Rezoning Transportation Analysis
Petition Number: Insert Zoning Petition #2021-039
General Location Identifier: Tax ID 04738107

Revision Log:

Date	Description
04-29-21	First Review (EL)
05-27-21	Second Review (EL)

Rezoning Transportation Analysis

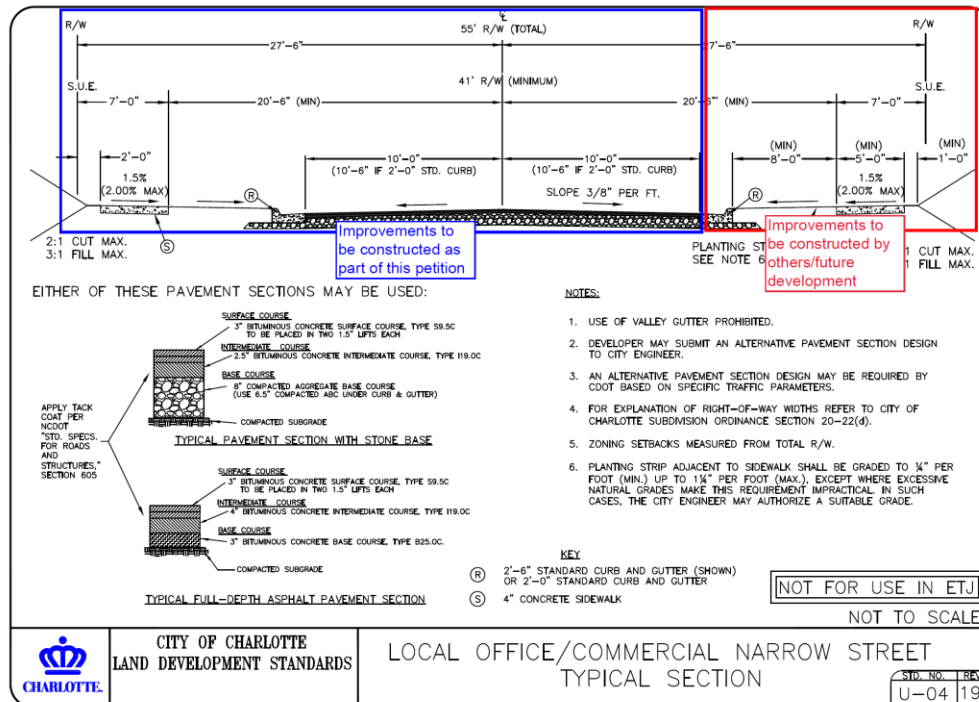
- a. **Outstanding Comment (site plan dated 5.17.21): Legranger Road:** Location of curb and gutter needs to be installed per CLDSM standard detail ~~U-07 - Local Collector Typical Section~~ ~~U-04 - Local Office/Commercial Narrow Street Typical Section~~, for the scope indicated in **blue** below. Pavement reclamation is needed to install this pavement section along the site's Legranger Road frontage. Include the typical section on rezoning sheet **RZ-02**. The roadway improvement is critical to be consistent with Policy 6 in the City Council-adopted University Research Park Area Plan. This improved cross-section for Legranger Road will create the appropriate network to support the signal installation project proposed by a separate transportation project (see Issue #3).

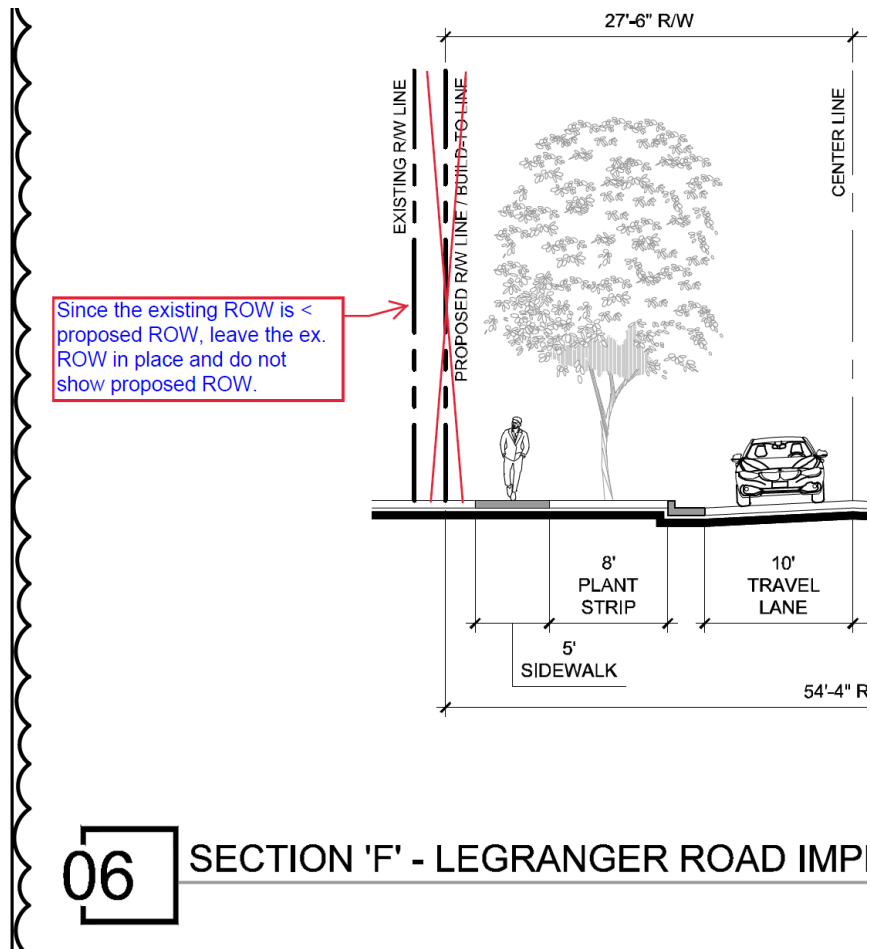
- b. ~~**Senator Royall Drive:** Location of curb and gutter needs to be dimensioned from road centerline on the site plan and as well as on the cross section shown below. A cross section for this road also needs to be provided along Development Area C.~~

Label and dimension the curb and gutter from the centerline for each road on the site plan.

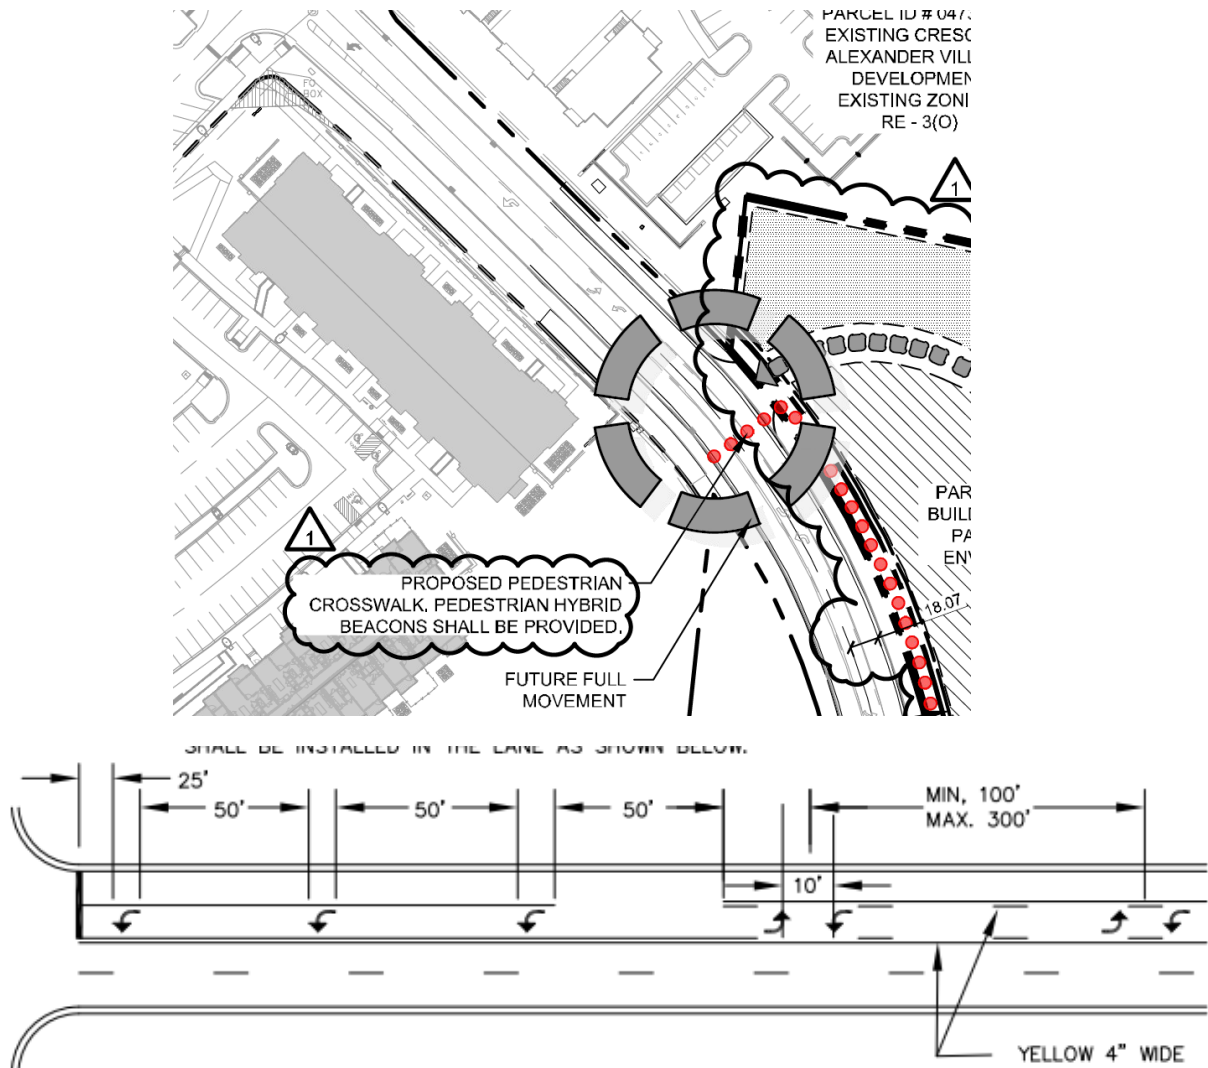
3. **Update to Comment 3 (site plan dated 5.17.21):** Since the proposed Legranger Road cross section has been revised to reduce the degree of right-of-way acquisition that may be needed, revise **Cross-section 6 – Section 'F'** to leave the existing right-of-way in place. The proposed improvements will also ensure that the pavement section on Legranger Road meets the typical full-depth asphalt pavement section per CLDSM, Plan Standard U-04/Revision 19. ~~Revise site plan and conditional note(s) to commit to dedicate 36 feet of public right-of-way from the Legranger Road centerline. The site plan shall label and dimension the right-of-way from the road centerline.~~

4. ~~Revise site plan and conditional note(s) to commit to construct an 8-foot planting strip and 5-foot sidewalk on Legranger Road per Chapter 19 / Chapter 20. The site plan shall label and dimension both items from the back of curb and gutter and road centerline.~~

~~Reference (CLDSM standard detail U-07) for street typical.~~

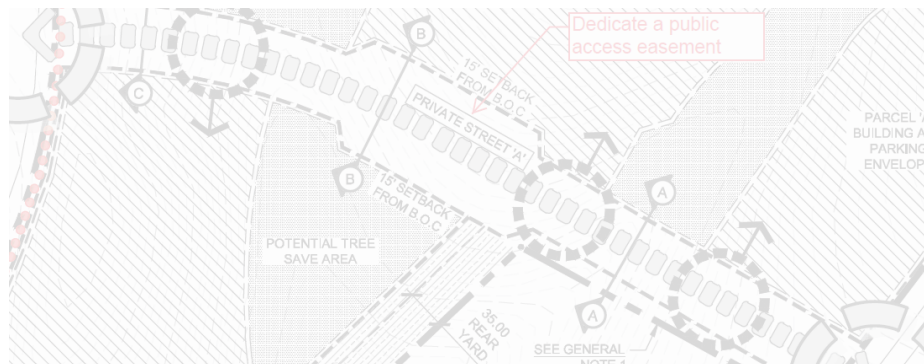
6. **Update to Comment 6 (site plan dated 5.17.21):** Revise the site plan and conditional note(s) to modify this proposed Senator Royall Place driveway to re-stripe the existing two-way left-turn lane to a dedicated southbound left-turn lane for this proposed driveway. The details can be finalized during permitting, but CDOT advises shifting this access further south to provide spacing to accommodate CDOT Pavement Marking Standards.
~~Site plan and conditional note(s) revisions are needed to clarify the proposed striping at the existing northbound left-turn lane into existing Crescent Village at Research Park. The left-turn lane striping should remain.~~

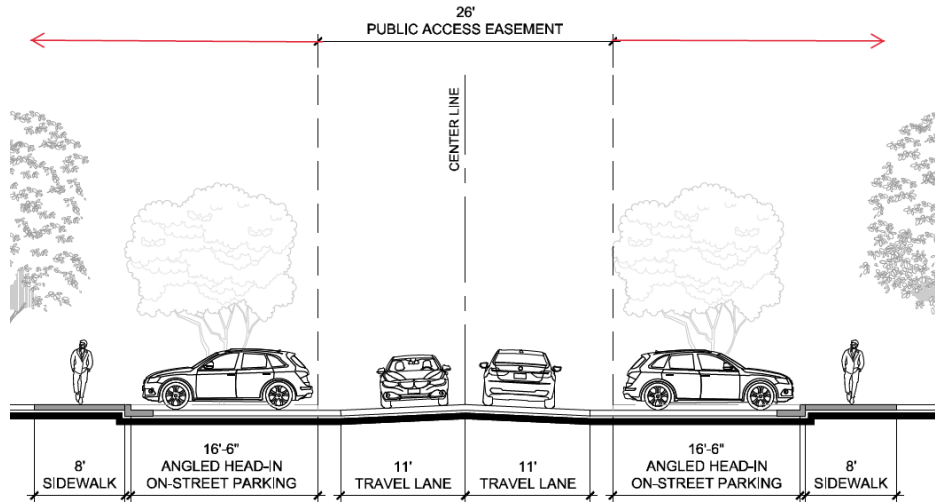
- Revised Comment (site plan dated 5.17.21):** Widen the proposed 26' public access easements on cross sections A-C to include the proposed sidewalk facilities. ~~Revise the site plan and conditional note(s) to dedicate a public access easement over Private Street A and call out the public access easement within the cross sections shown on rezoning sheet RZ-02.~~

c. A twelve (12) foot multi-use trail will be constructed along the Site's Senator Royall Drive frontage provided; however, the width of the multi-use path may be reduced to no less than eight (8) feet, with the approval of CDOT, in certain "pinch point" locations.

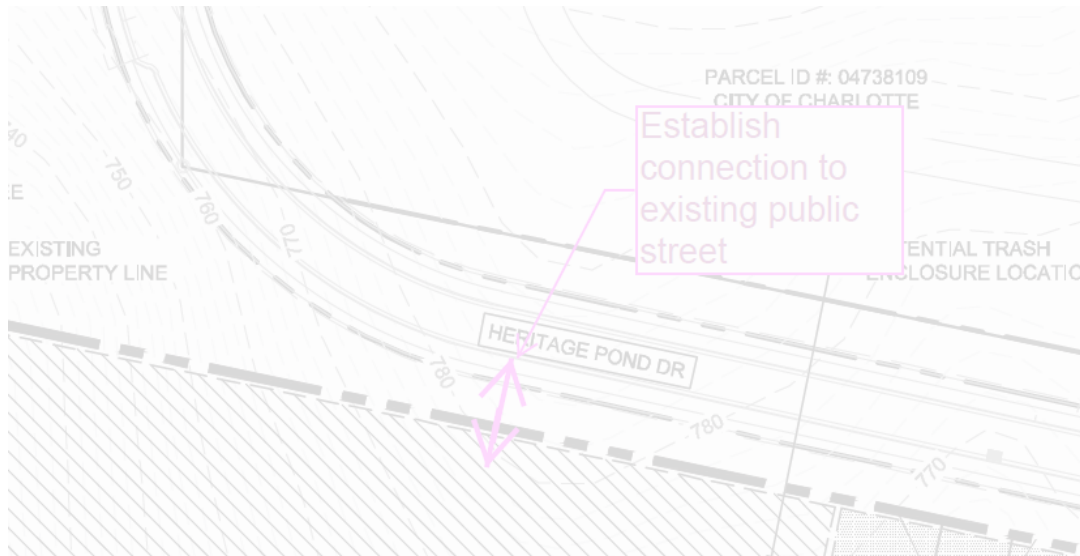
8. ~~Site plan and conditional note (**Section 7.c.**) revisions are needed to revise the clouded language below to "the width of the multi-use path may be adjusted upon approval of CDOT, where a 12-foot multi-use path cannot be constructed due to existing constraints."~~

02 SECTION 'B' - NEW PRIVATE STREET WITH ANGLED ON-STREET PARKING

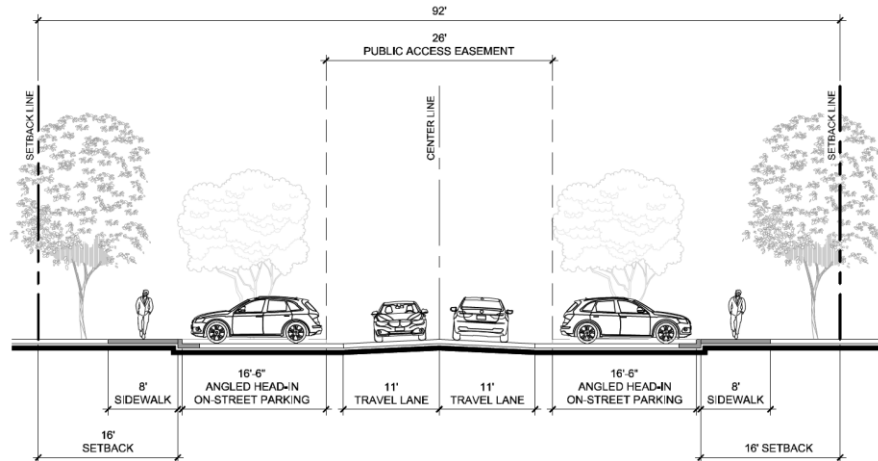
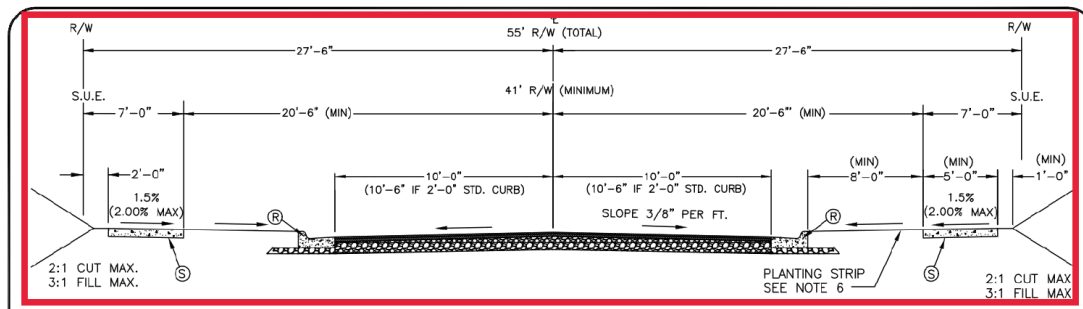
10. **New Comment (site plan dated 5.17.21):** Revise conditional note **Section 4.c.** to clarify that the pavement will meet public street standards and remove the reference that Private Street A will be designed per CDOT standards. CDOT standards do not permit angled head-in parking.
